# **NATIONAL BOARD INSPECTION CODE SUBCOMMITTEE INSTALLATION**

## **AGENDA**

Meeting of July 9, 2025  
Cincinnati, OH

POOL HEATERS IN BATTERY – ACCEPTABLE PIPING INSTALLATION

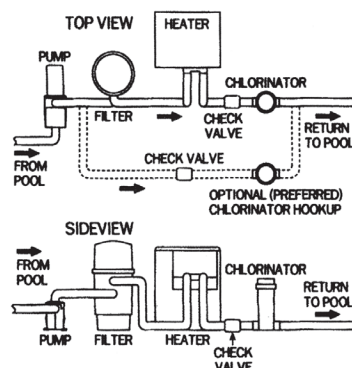
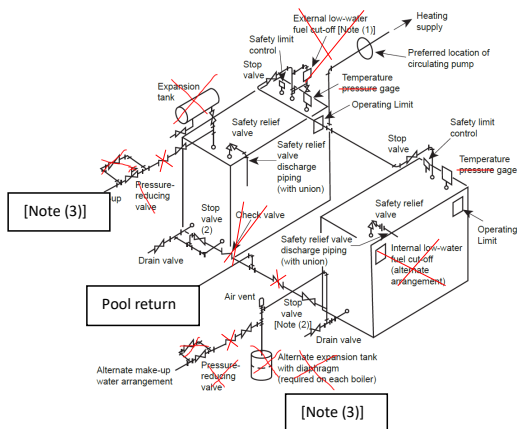
*[Notes for NBIC editor/graphics: This image is taken from the water boiler piping diagram. Remove low-water cutoffs. Remove expansion tank and associated piping. Remove check valves. Replace "temperature pressure gauge" with "temperature gauge".]*
